DOCUMENT - 2026-264T
Interior and Exterior Renovations at Peel Regional Police 12 Division, 4600
Dixie Road, Mississauga
ADDENDUM NO. 6

Referring to the above Document 2026-264T - Interior and Exterior Renovations at Peel Regional Police 12 Division, 4600 Dixie Road, Mississauga, please note the following:

A211

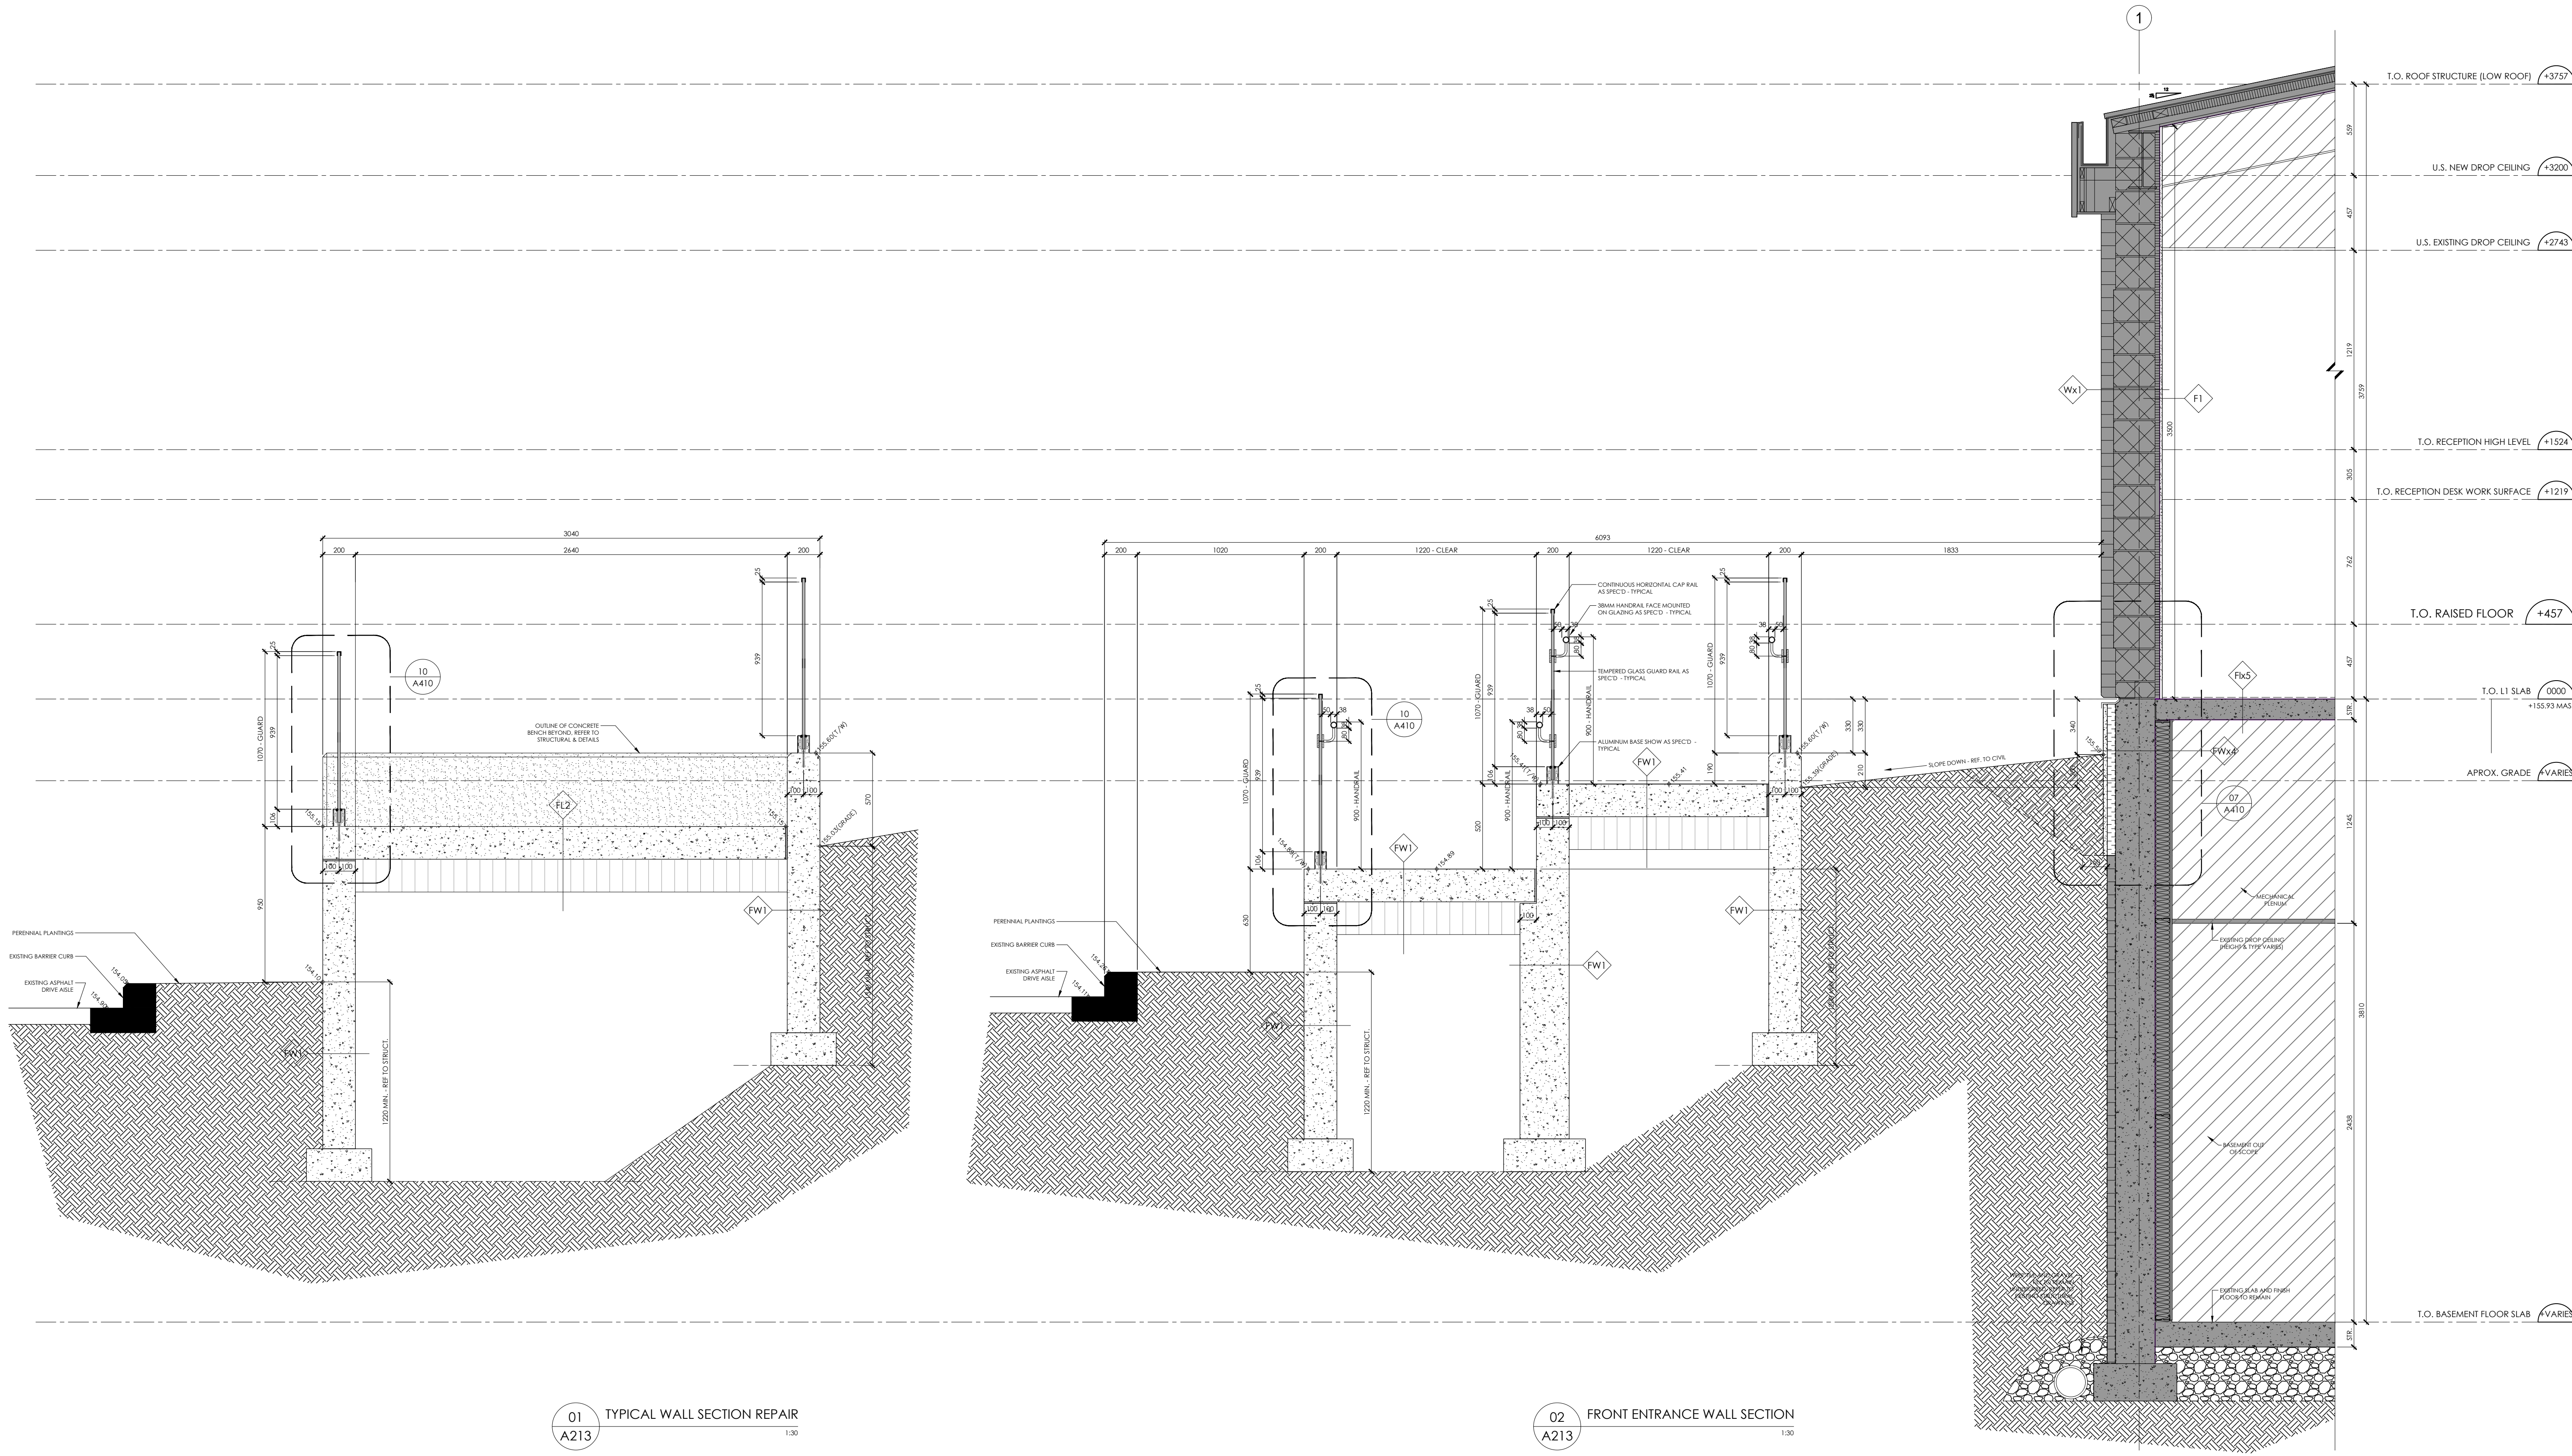
Drawing A120 references Section Detail 03/A210; however, upon review of Drawing A210, Section 03 does not appear to be included. Please clarify the intended section reference and provide the correct drawing/detail number or issue a revised drawing set identifying the applicable section.

Missing ramp sections have been added on A213. A120_R14, and A211_R14 have been revised for updated detail references.
